RE: REVISED DRAINAGE PLAN FOR WESTERN-WIRELESS ACT BUILDING (E21-D31)
REVISION DATED 8/14/98

PROJECT TITLE: WESTERN WIRELESS - ACT BUILDING ZONE ATLAS/DRNG. FILE: E-21-Z

RE: DRAINAGE PLAN FOR WESTERN-WIRELESS ACT BUILDING (E21-D31)
ENGINEER'S STAMP DATED 6/30/98

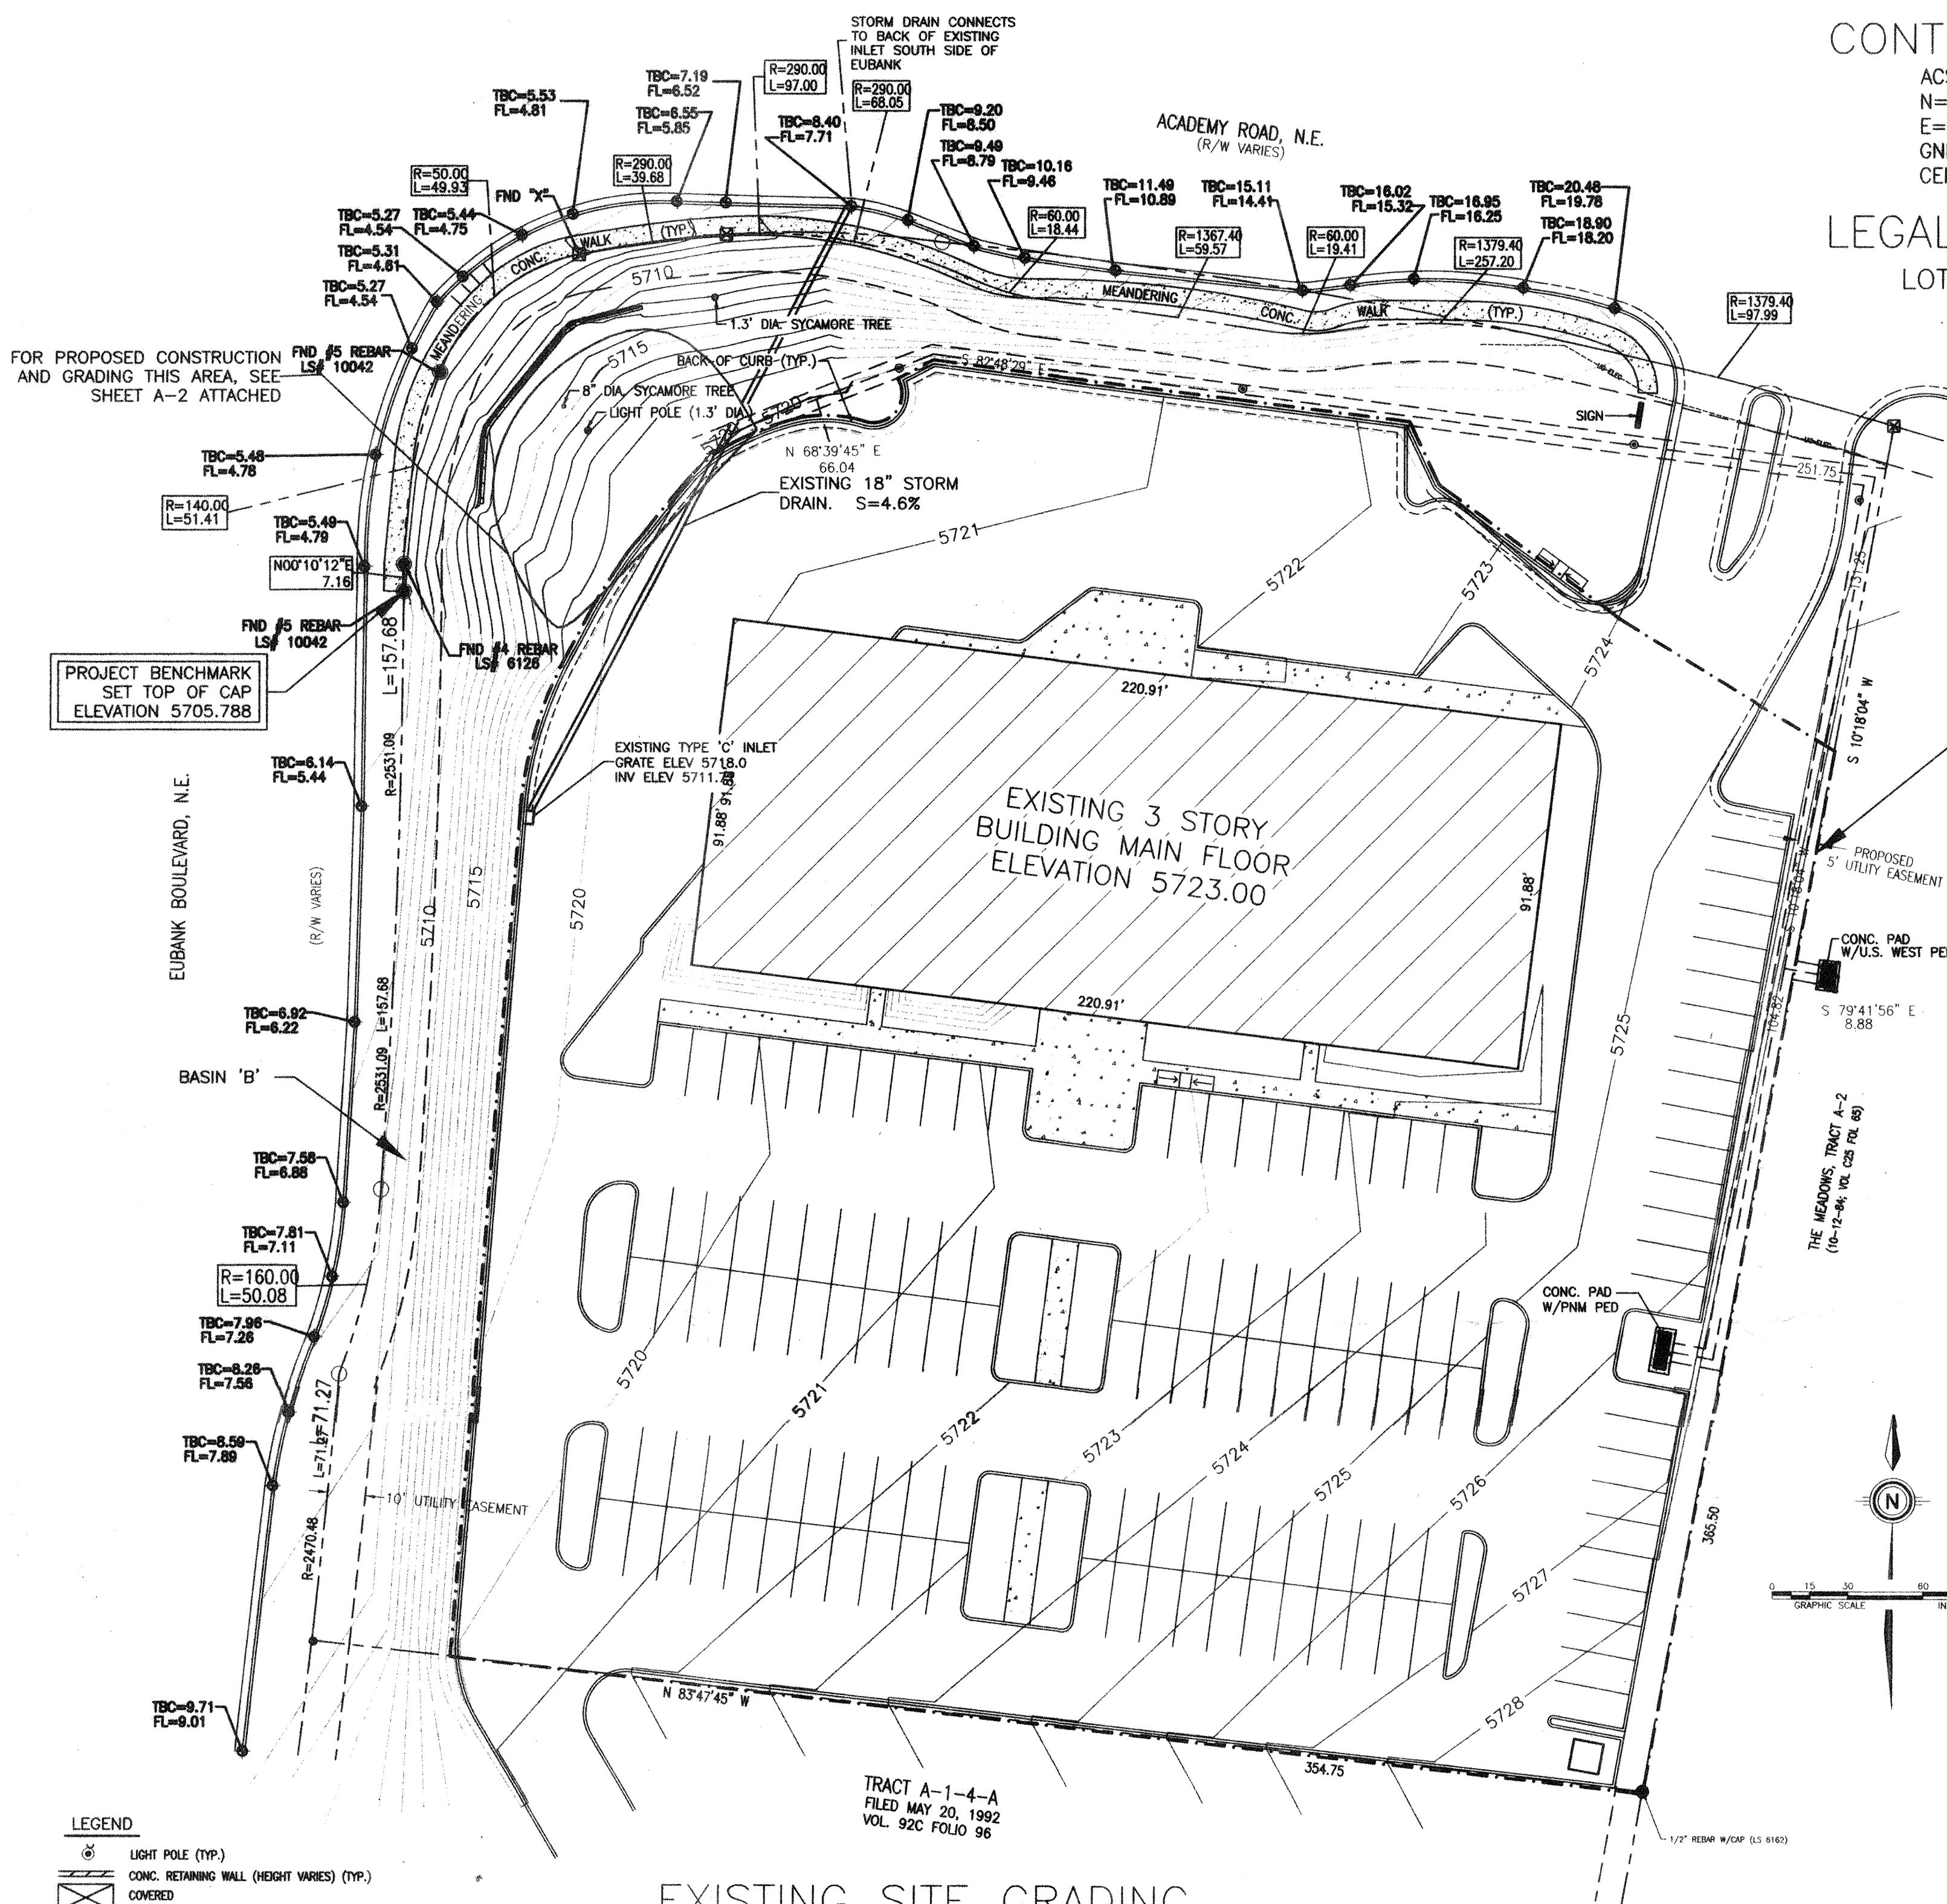
1. SO19 format on the plan drawing (six notes and sign-off block) extra copy with the resubmittal.
2. Top of curb and flowline elevations on Eubank & Academy NE.
3. Inverts for the all the pipes thru the sidewalk.
